CITY OF MERCED
Planning & Permitting Division

STAFF REPORT: #15-11

SUBJECT: **Conditional Use Permit #1200**, initiated by BP Investors, LLC, property owners. This application involves a request to construct a 216-unit apartment complex in two phases on a 9.8-acre parcel located on the north side of Merrill Place (extended) approximately 1,200 feet east of G Street. This parcel is located within Residential Planned Development (RP-D) #61 and has a Village Residential (VR) General Plan designation.
PUBLIC HEARING

CONCEPT
SITE PLAN
Sheet A1
Scale 1"=40'-0"
March 22, 2015
Revised May 04, 2015

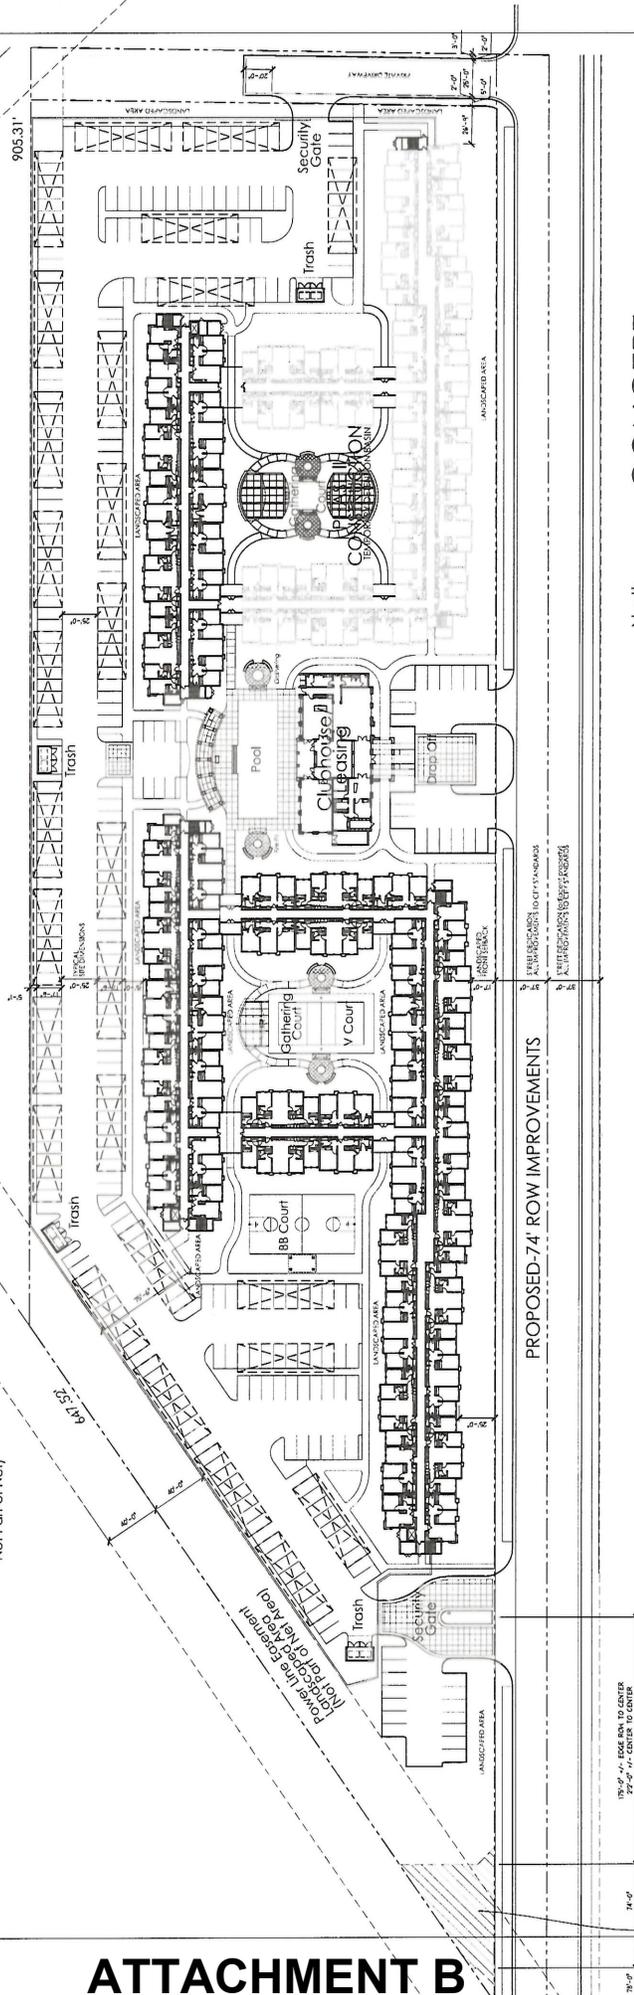
- 29) The entrance on the east side of the project site shall be moved north to align with the internal drive aisle on the north side of the apartments or an additional entrance may be added in this location. The road accessing the driveway on the east side is a private road and must be paved to meet requirements for Fire Department access.

Primary access to the site would be near the western edge of the property (Attachment B). A secondary entrance would be provided on the east side of the property. As shown on the site plan at Attachment B the entrance would be located near the southeast corner of the site. Due to concerns from the Fire Department about being able to get their Fire Engine in and out of the site, Condition #29 requires this entrance to be moved to the north to align with the internal drive aisle on the north side of the apartments or an additional entrance added to align with this drive aisle allowing the Fire Engine access to the site.

Building Setback: According to the design standards, the front setback should be a minimum of 30 feet. The proposed site design shows the setback varies from 17 to 25 feet (see Site Plan at Attachment B). In order to achieve the 30-foot setback, the open space area between the buildings would have to be reduced or the area between the buildings and the carports would have to be reduced. In an R-4 zone, the minimum front yard setback is only 15 feet. While the proposed design does not comply with the design standards, it seems reasonable to allow the reduced setback given the fact that the proposed setback is greater than what would be required by standard apartment zoning and to allow more useable open space for the tenants.

Figure 4.24
Collector Street Cross-Sections

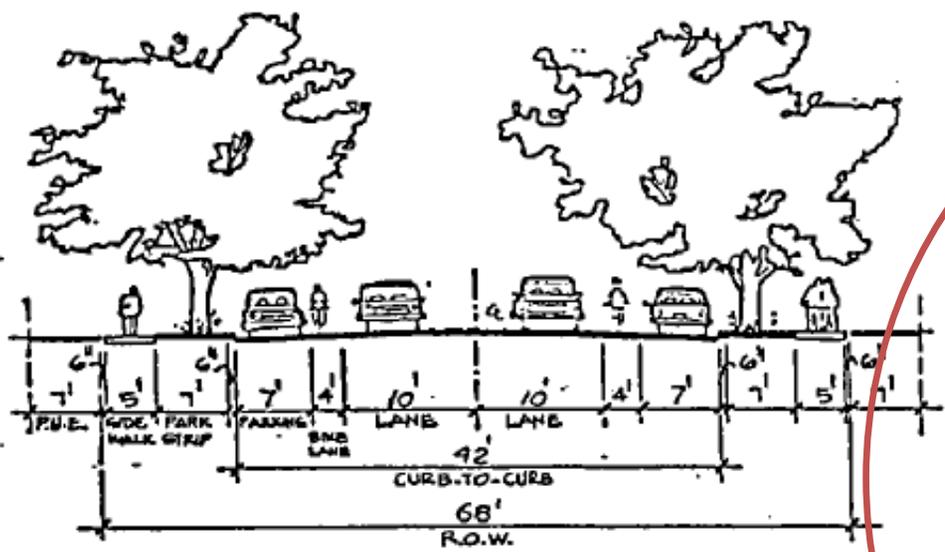
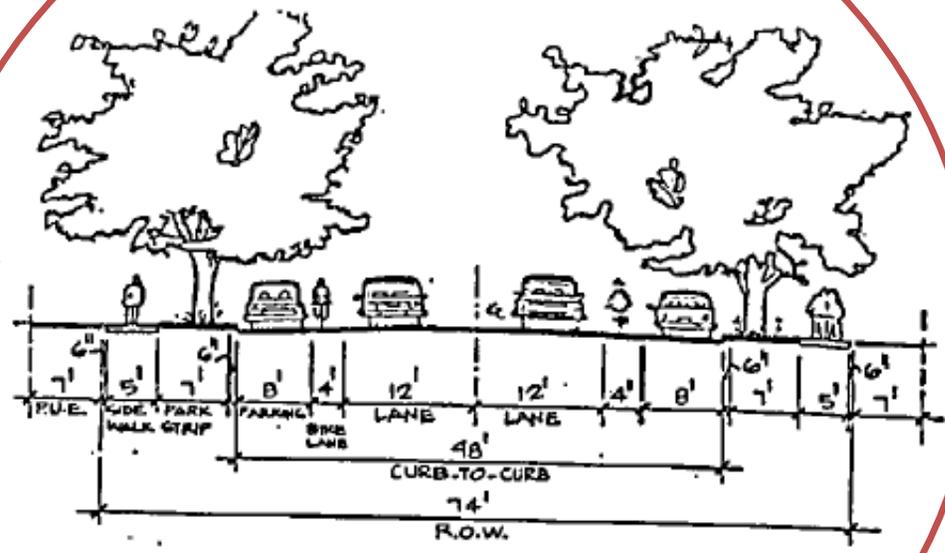
- 10) This project is required to construct Merrill Place (a Collector Road with a 74-foot right-of-way) from G Street to the eastern edge of the project site. The road shall be constructed per City Standard ST-2 and Figure 4.24 (Collector Street Cross-Sections) of the *Merced Vision 2030 General Plan* to include a 5-foot wide bike lane. The north side of Merrill Place along the project frontage shall include full improvements (i.e., the travel lane, sidewalk, curb, gutter, 5-foot-wide bike lane with striping, street trees, park strip landscaping, and street lights. The north side of Merrill Place from G Street to the project's western edge shall include the travel lane, 5-foot-wide bike lane with striping, street lights, curb, gutter, and sidewalk. The south side of Merrill Place shall include the travel lane, 5-foot-wide bike lane with striping, street lights, curb, and gutter. The developer shall be eligible for reimbursement for any improvements that do not front the project site in accordance with Merced Municipal Code Section 17.58.030 and 17.58.040.
